Planning and Zoning Board Agenda September 27, 2022 Room 102 – 7:00 P.M.

1. Address: 1353 Lee Street

Case Number: 22-035-FPLAT

Date: September 14, 2022
To: John Carlisle, Director of Community and Economic Development
From: John La Berg, P.E., Civil Engineer
Cc: Jon Duddles, P.E., Assistant Director of Public Works and Engineering
Subject: 1353 Lee St. Proposed 2 lot commercial subdivision

MEMORANDUM

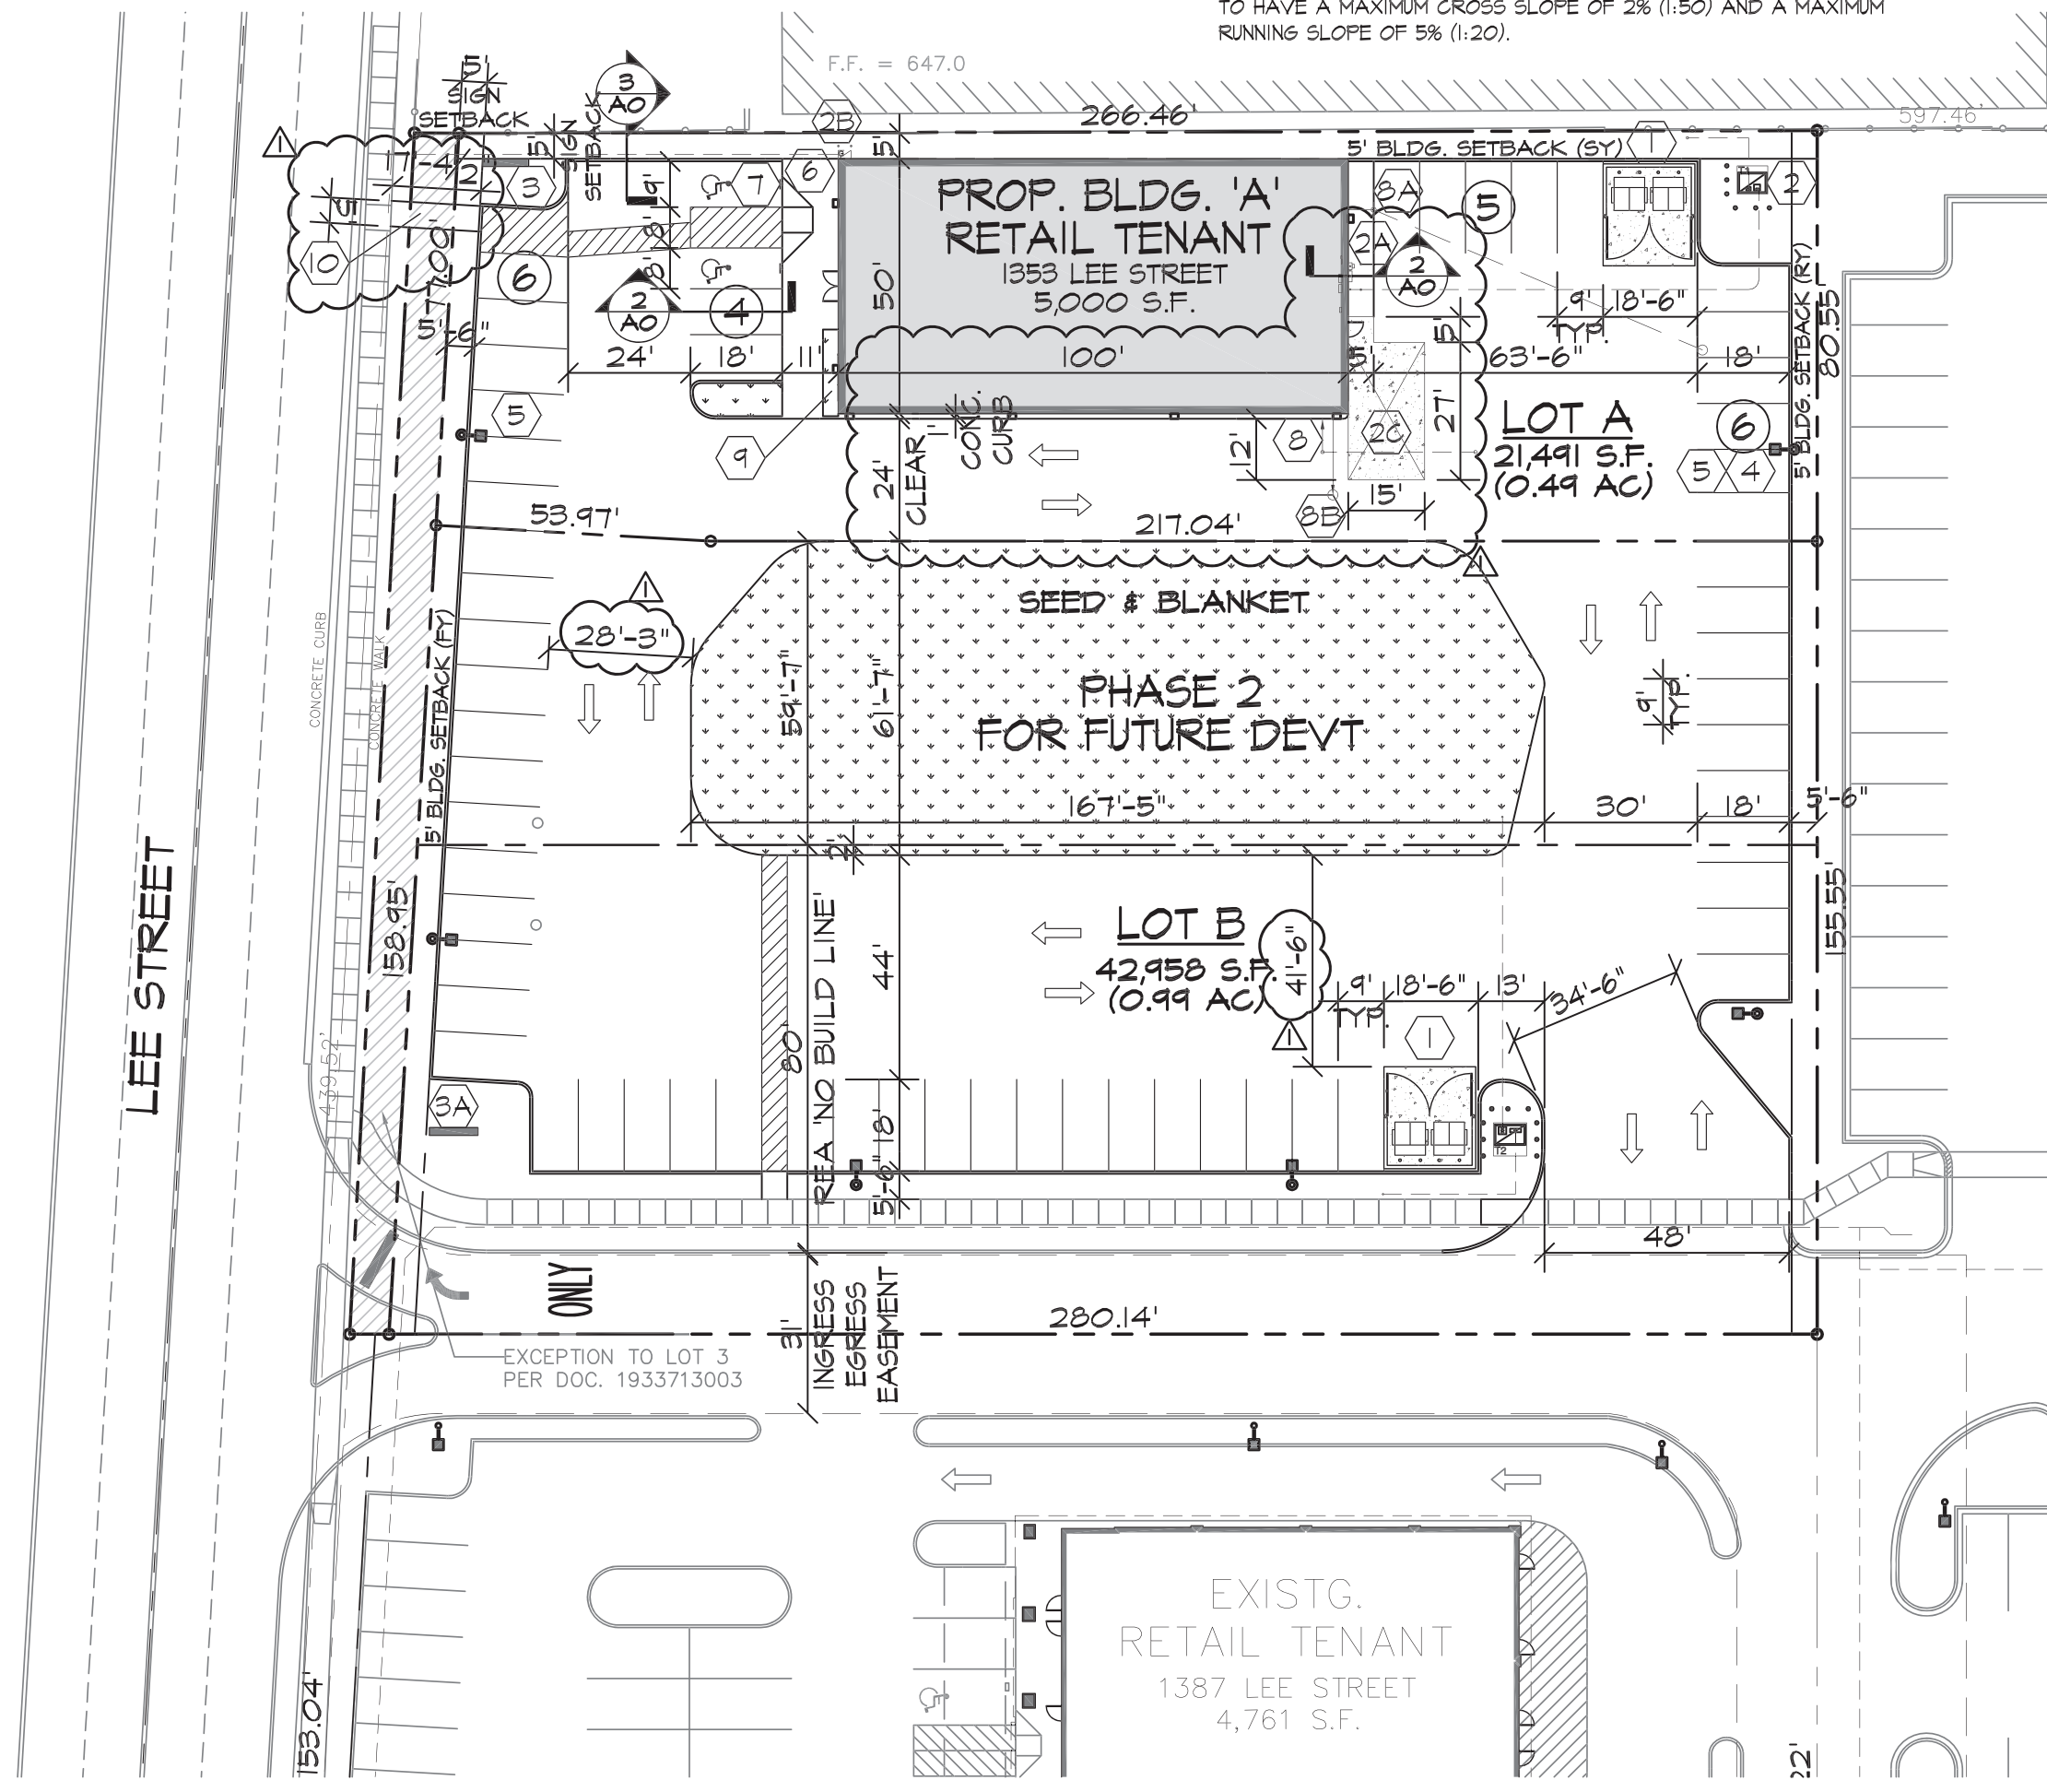
Per your request, Public Works and Engineering has just a few issues with the above final engineering plans. We have no objection to approving them as noted once the MWRD permit is approved by the MWRD.
